Recycled Water Expansion Project

Addendum No. 2

November 18, 2026

The following is Addendum No. 2 to the Mendocino City Community Services District – Recycled Water Expansion Project.

Client MENDOCINO CITY COMMUNITY SERVICES DISTRICT
Project RECYCLED WATER EXPANSION PROJECT
Title RECYCLED WATER LINE - STA 10+00 TO 13+00
Project No. 12619547
Original Size ANSI D
Drawing No. C-101
Sheet 5 of 31

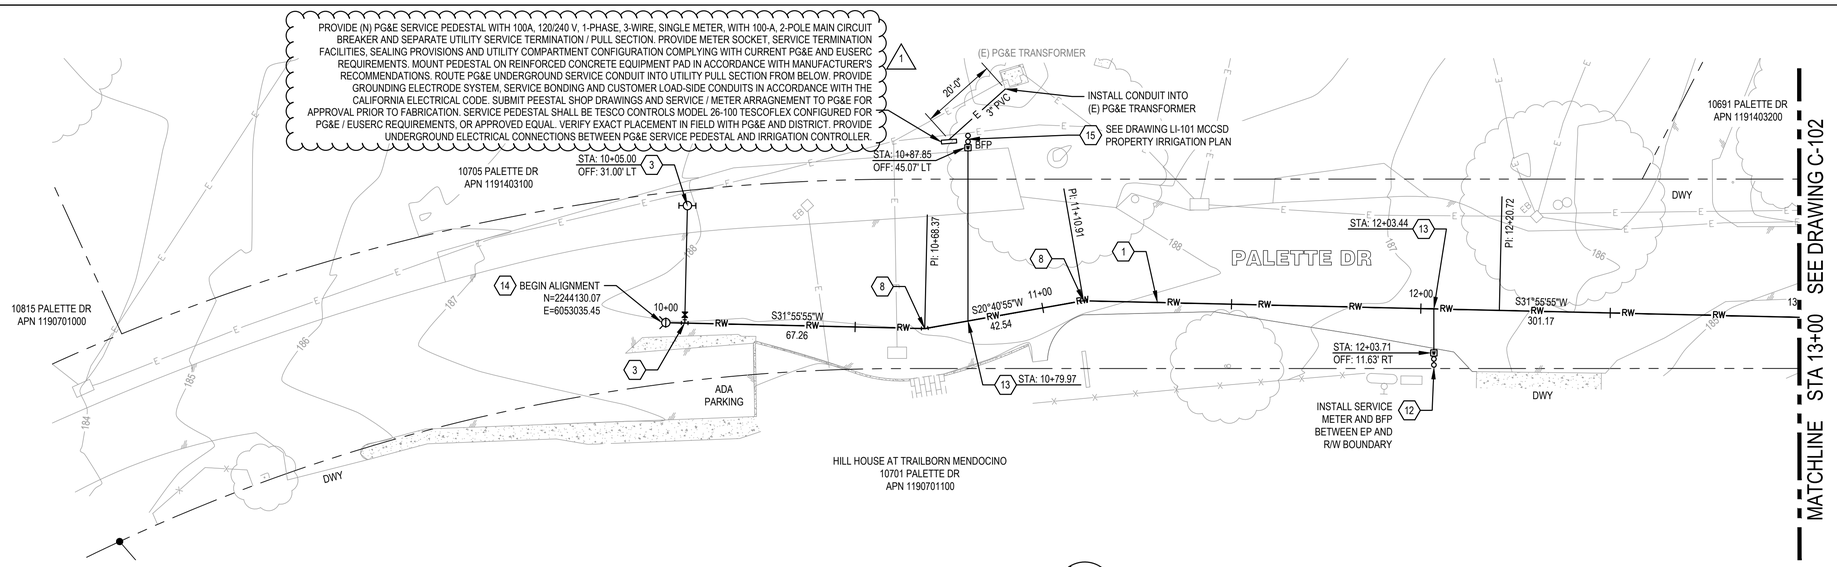
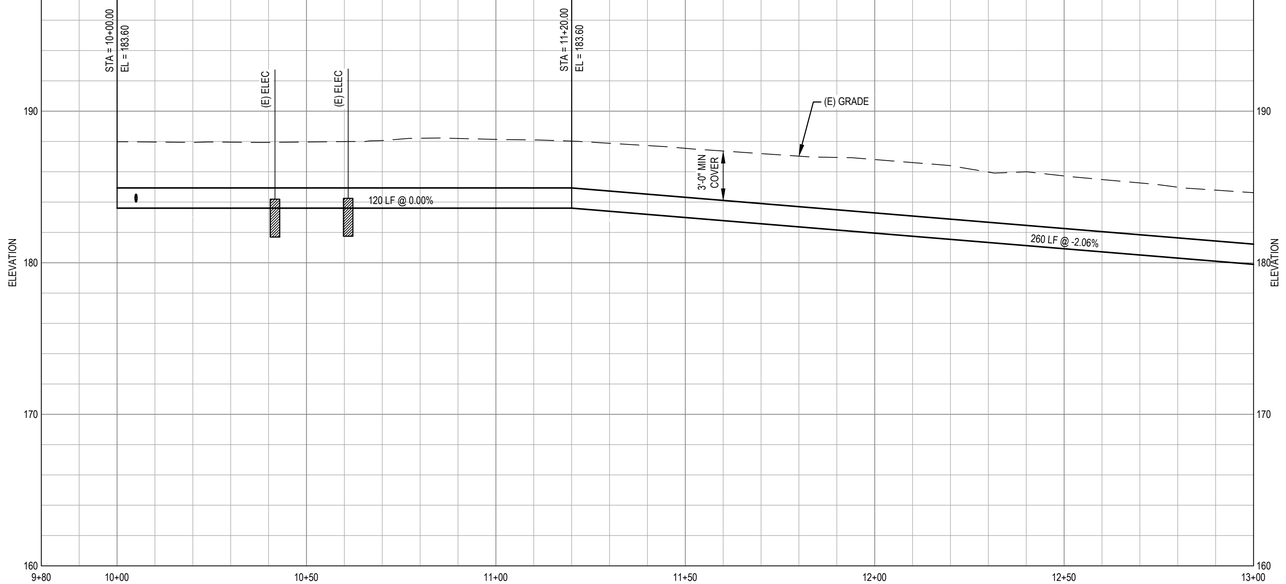
Question 3: Where does the irrigation controller at MCCSD get 120 volt power from?

Response 3: Power is provided by the new PG&E service, which is shown on Drawing C-101.

1. Drawing C-101 is revised to clarify PG&E service requirements.
2. Drawing C-107 is revised to clarify bid schedule.
3. Drawing C-110 is revised to clarify main size, north arrow orientation, sewer lateral requirements and bid schedule.
4. Drawing C-402 is revised to clarify PG&E service requirements.
5. Drawing C-501 is revised to clarify Detail 2 surface restoration requirements
6. Drawing C-502 is revised to clarify Detail 1 fire hydrant color requirements.
7. Drawing C-503 is revised to clarify Detail 5 the depth of the wet well and referencing a new wet well cover detail on new Drawing C-504.
8. Drawing C-504 is added showing the details of the new wet well cover including davit crane sleeve and lifting hooks. The davit crane sleeve will be field located and installed.

Client MENDOCINO CITY COMMUNITY SERVICES DISTRICT
Project RECYCLED WATER EXPANSION PROJECT
Title RECYCLED WATER LINE - STA 40+00 TO 44+50
Project No. 12619547
Original Size ANSI D
Drawing No. C-107
Sheet 11 of 31

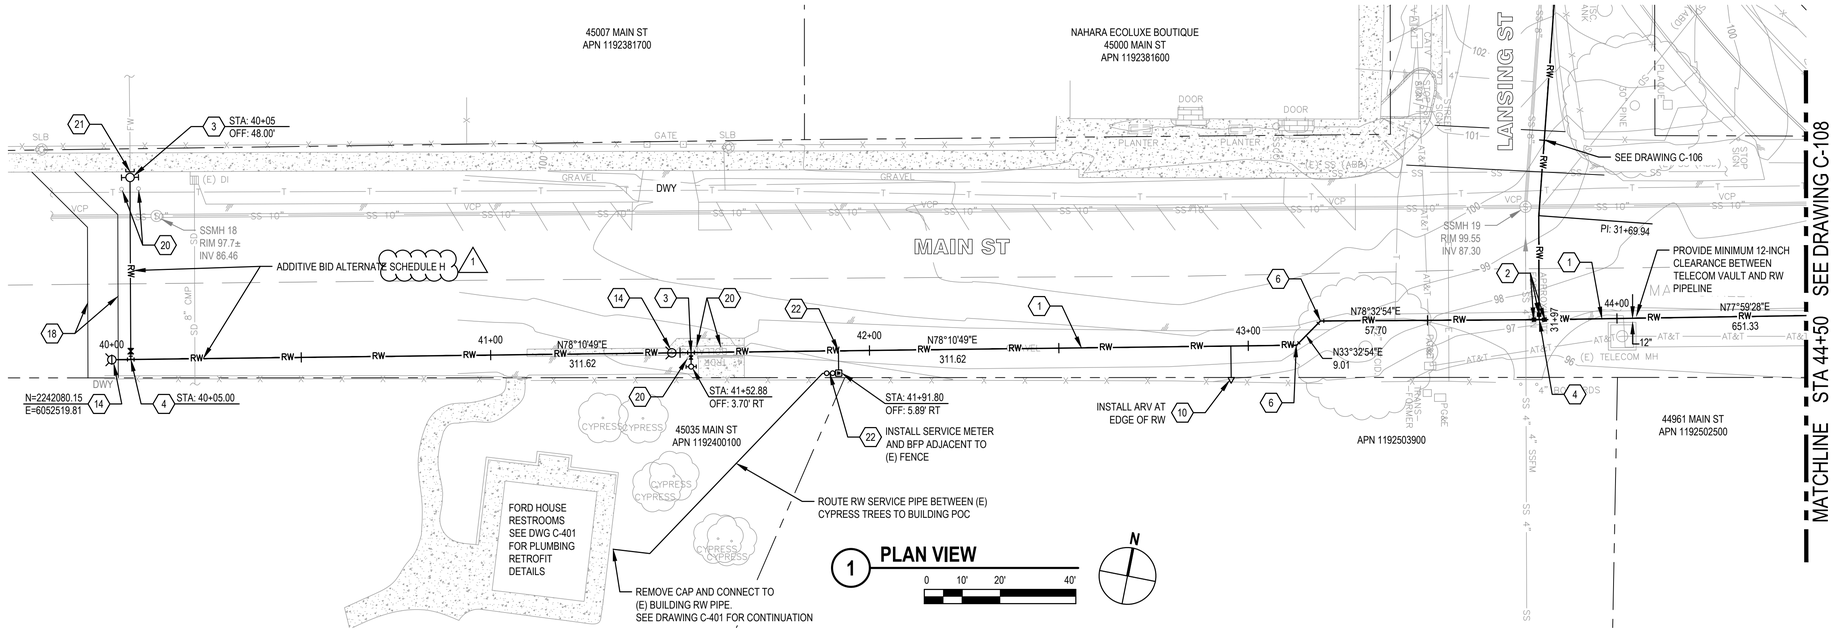
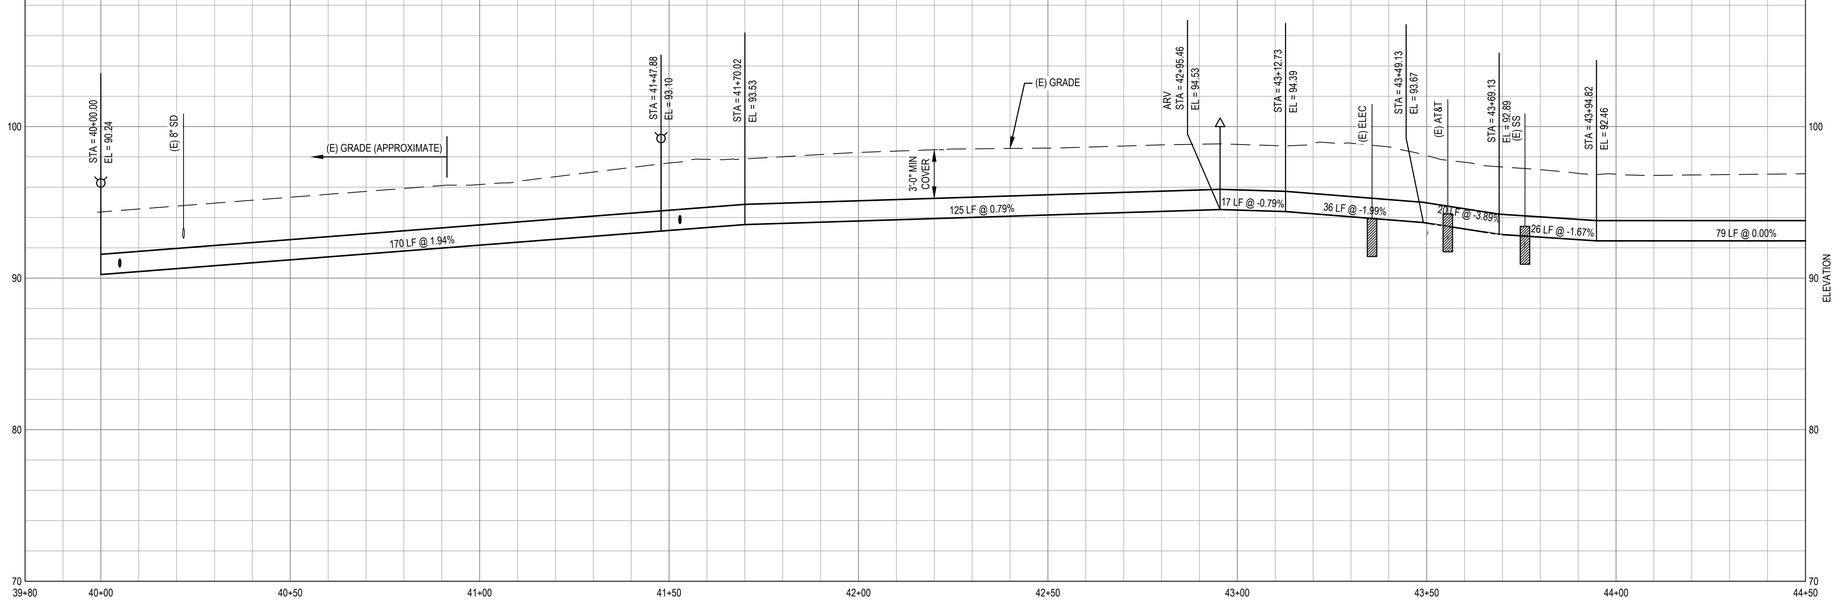
Question 17: Sheet C107 has two call outs for additive bid alt 1. Please confirm this is the H-1 additive item and confirm that it includes everything from station 40+00 to 41+50.

Response 17: Additive Bid Alternate Schedule H extends the recycled water main approximately 150 feet between STA 40+00 to STA 41+47.88.

Client: MENDOCINO CITY COMMUNITY SERVICES DISTRICT
Project: RECYCLED WATER EXPANSION PROJECT
Title: EVERGREEN STREET SANITARY SEWER LINE
STA 60+00 TO 62+84
Project No. 12619547
Original Size: ANSI D
Drawing No. C-110
Sheet 14 of 31

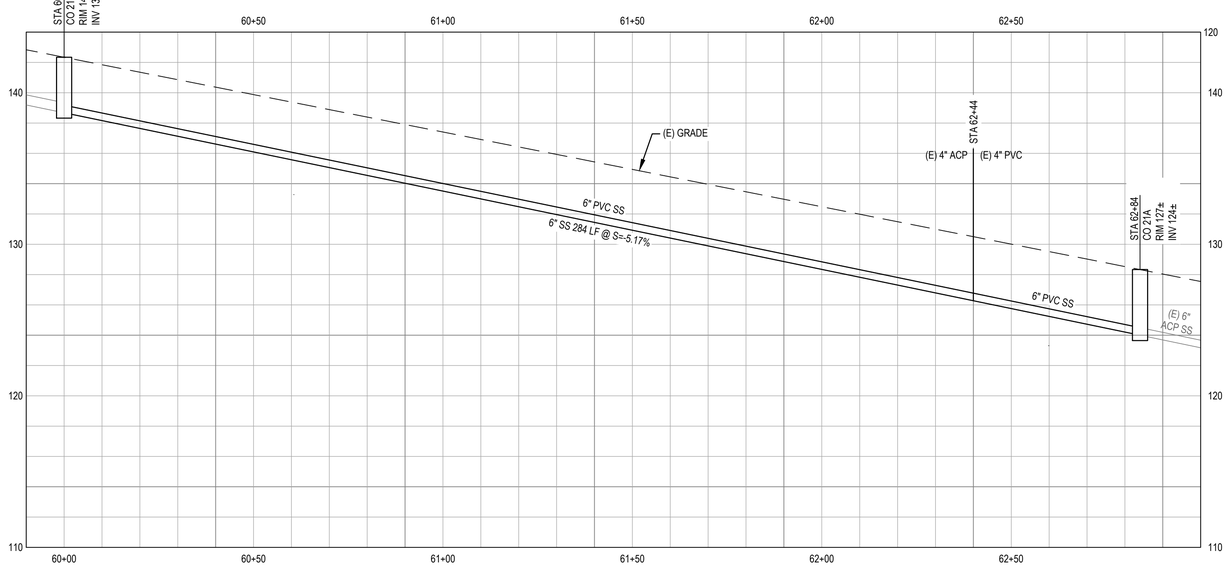
Question 18: The plan sheet keynotes on C110 call out all the sewer line work as bid schedule G. Please confirm this is an error.

Question 19: The bid schedule item F-5 calls for five new two-way cleanouts when there is seven laterals being reconnected. These are not shown on the plans, and no detail is provided. Please advise.

Question 20: Please confirm the sewer size on C110. The bid form and profile view says 6" sewer main, sheet C110 keynotes says 8".

Question 21: Please confirm that we are only required to reconnect the sewer laterals on sheet C110 to the new 8" or 6" line in Evergreen St and will not have to chase them back any further than that as indicated by 4" SS lines shown on the plans.

Response 18: The work on C-110 is paid under Schedule F.

Response 19: Provide new cleanouts on the sewer laterals that are reconnected on the east side of the main only similar to City of Santa Rosa Standard 513-A.

Response 20: The sewer size on C-110 is 6 inch.

Response 21: See response to Question 19. The design intent is to provide the cleanout within 5-ft of the main.

1. REMOVE (E) 4" ACP SEWER MAIN. INSTALL (N) 6" PVC SS MAIN IN THE SAME ALIGNMENT (BID SCHEDULE F).
2. REMOVE (E) CLEANOUT AND PROVIDE (N) SSMH. SEE DETAIL 1 ON DRAWING C-503 (BID SCHEDULE F).
3. RECONNECT (E) SS LATERAL USING INSERTA TEE FITTING OR APPROVED EQUAL. ENSURE A WATERTIGHT CONNECTION (BID SCHEDULE F).
4. PROVIDE 2-WAY CLEANOUT SIMILAR TO CITY OF SANTA ROSA STANDARD 513-A. INSTALL WITHIN 5-FT OF MAIN CONNECTION (BID SCHEDULE F).

Client MENDOCINO CITY COMMUNITY SERVICES DISTRICT
Project RECYCLED WATER EXPANSION PROJECT
Title HEIDER FIELD PG&E SERVICE
Project No. 12619547
Original Size ANSI D
Drawing No. C-402
Sheet 16 of 31

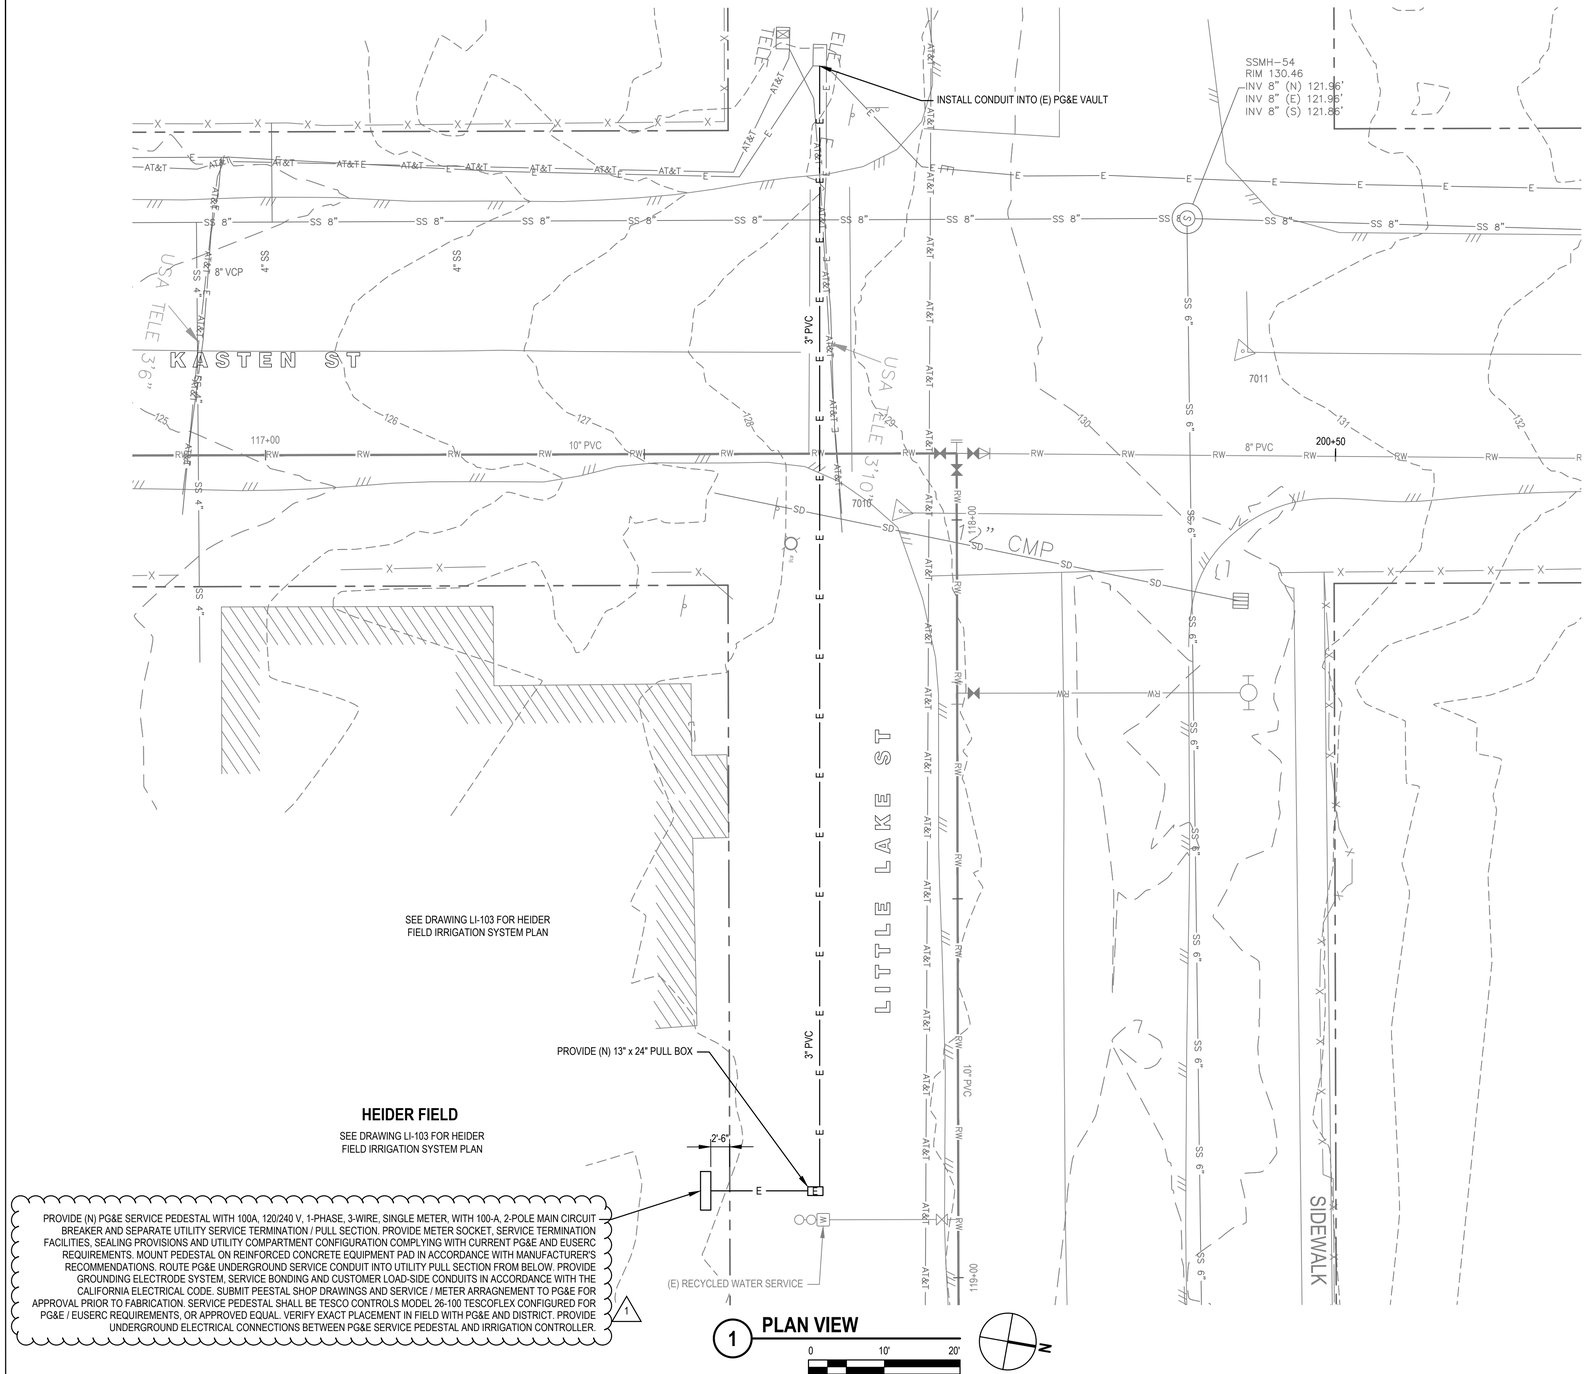
Question 2: On sheet C-402 the plans show a 13x24 pull box in Little Lake St with no other information regarding the box. Typically PG&E will require a specific type of box. Please provide a PG&E code for this box.

Question 5: Where does the irrigation controller at Heider get 120 volt power from?

Response 2: Provide a PG&E-approved 8,000-lb polymer-concrete cover, installed in accordance with PG&E Standard 028028.

Response 5: Power is provided by the new PG&E service, which is shown on Drawing C-402.

Client MENDOCINO CITY COMMUNITY SERVICES DISTRICT
Project RECYCLED WATER EXPANSION PROJECT
Title CIVIL DETAILS 2
Project No. 12619547
Original Size ANSI D
Drawing No. C-502
Sheet 18 of 31

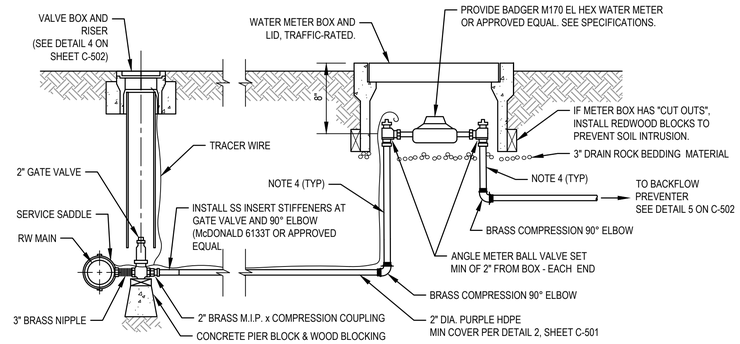
Question 14: Detail 3/C-502 shows a gate valve with an accompanying valve box for the water service with meter. Specs (page 33 11 00 – 8) have this service built as a saddle with a corp stop, which is typical construction. It is not standard practice to have a valve box for a corp stop. Please confirm that a valve box is only needed at an actual gate valve, in this case only the ones listed as Bid Item A-10.

Response 14: Provide gate valves in valve boxes with tapping service saddle for 2-inch and larger recycled water services. Refer to similar City of Santa Rosa Standard Detail 865-A. 1-inch recycled water services shown on the Drawings are to be provided in accordance with City of Santa Rosa Standard 861.

1 CONCRETE WET WELL COVER NOT TO SCALE

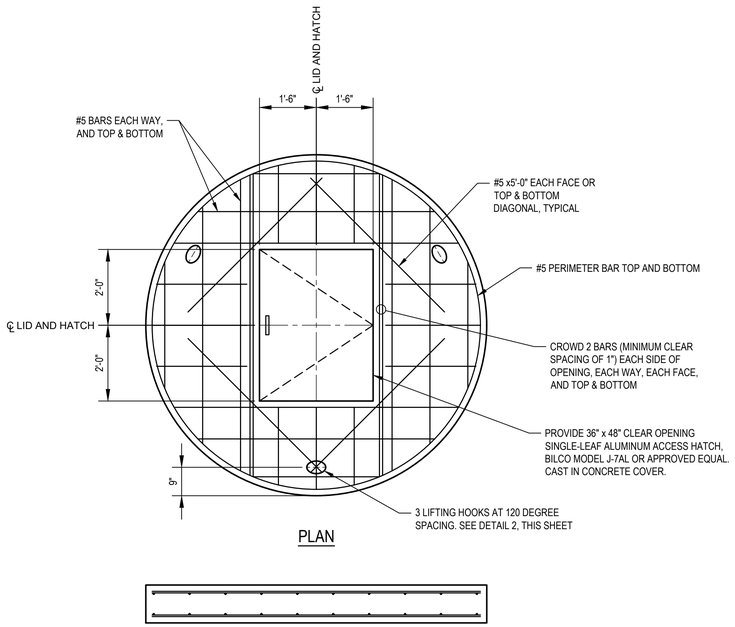
Question 7: Will a square/rectangular top with the hatch cast into it be acceptable for the Wet Well? Precasters can not quote this as circular due to size limitations on their circular forms.

Response 7: Provide a circular reinforced concrete top with the access hatch cast in. A detail for a cast-in-place construction is added to Drawing C-502.
